Amendments to the drawings:

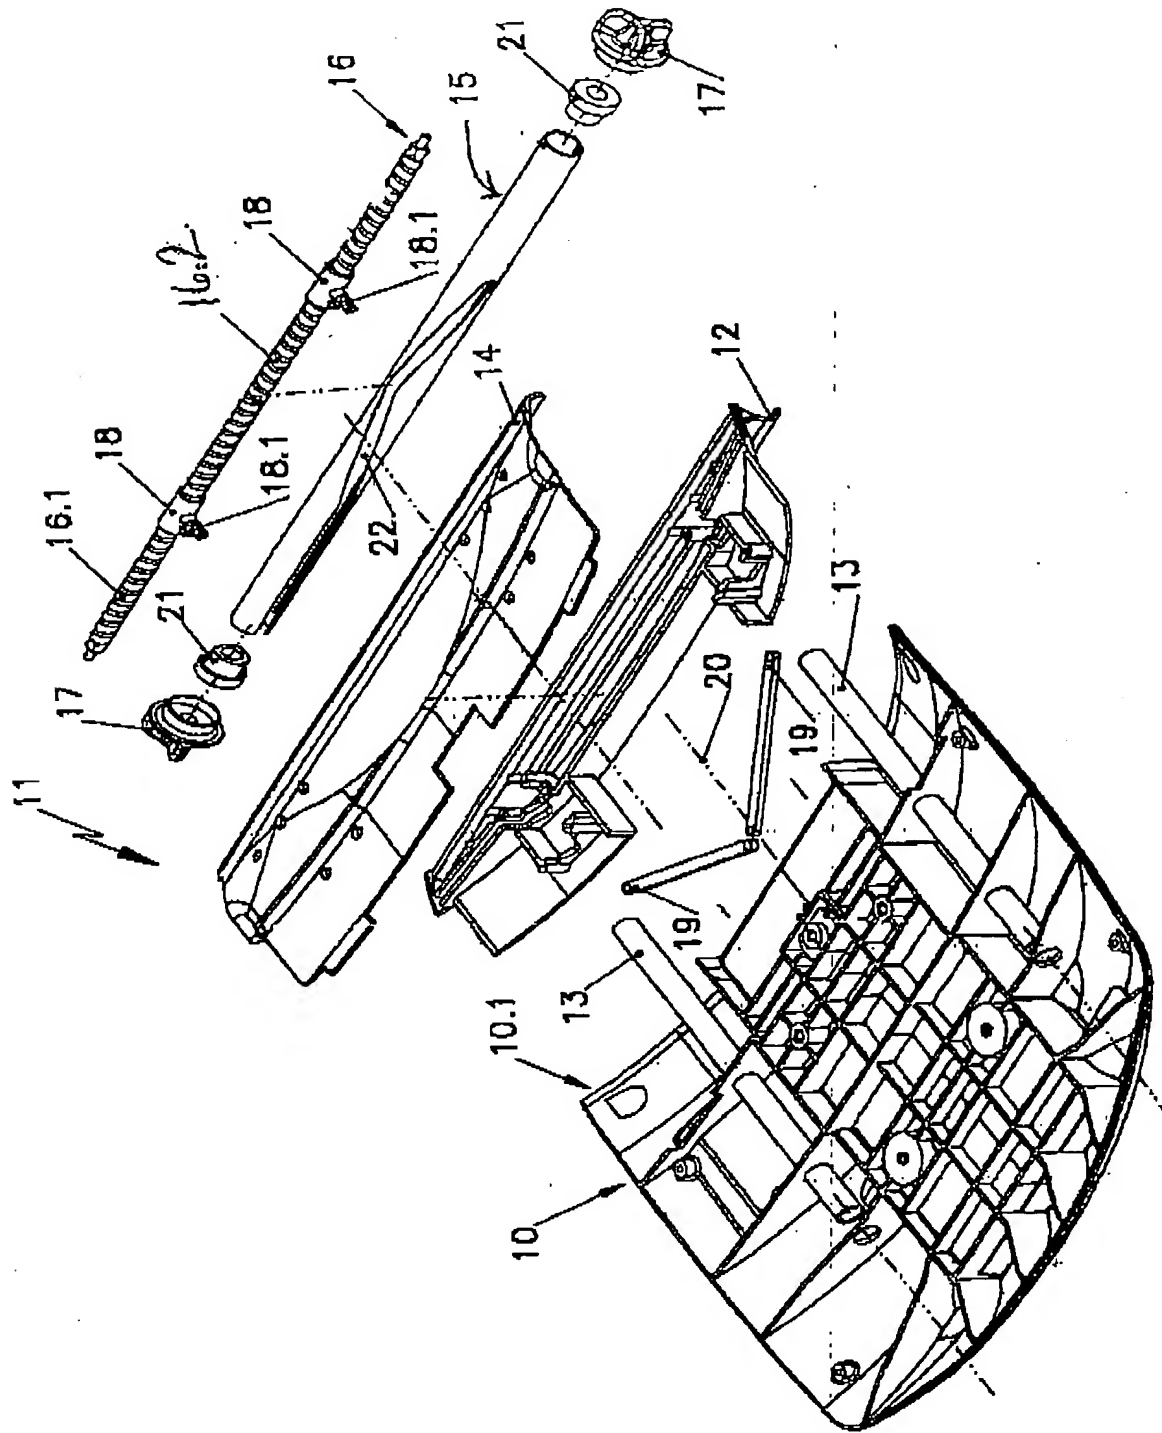
The attached sheet of drawings includes changes to Fig. 1. This sheet, which includes Fig. 1, replaces the original sheet including Fig. 1. In Fig. 1, element 16.2 has been indicated and the lead line to element 15 has been modified to indicate the cushion receiving tube as a whole.
